Subject: LOS ANGELES ZOO: LANGUR BRIDGE STRUCTURAL DEFICIENCIES,

REPAIRS, AND/OR REPLACEMENT

Subject: LA Zoo – Langur Bridge Inspection

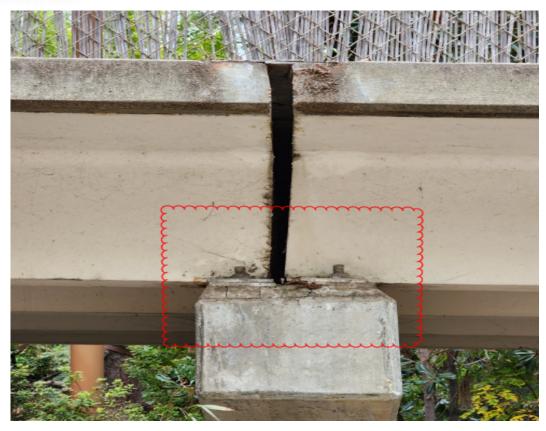
The superstructure, deck, and girders appear to be in good condition with minor deck spalling on the East and West sides. The double tee girders connecting to the North pier are in poor condition. There are two significant spalls, approximately 18" H x 29" W x 6.5" D and 20" H x 32" W x 4" D, at the bearing plates exposing the anchor bolts and reinforcement at the north pier on one face. The bearing plates on the pier have no supports remaining, therefore it poses a major safety concern. From an elevation view, the concrete girders seated on the supporting piers are offset approximately two inches at the north pier and may be a contributing factor to the large distress.

It is recommended to close the bridge immediately to both vehicular and pedestrian traffic and for LA Zoo or GSD to hire a licensed Civil or Structural Engineer in the State of California to provide the repair recommendations. Alternatively, depending upon LA Zoo's needs, the existing bridge can be demolished for the construction of a new bridge.
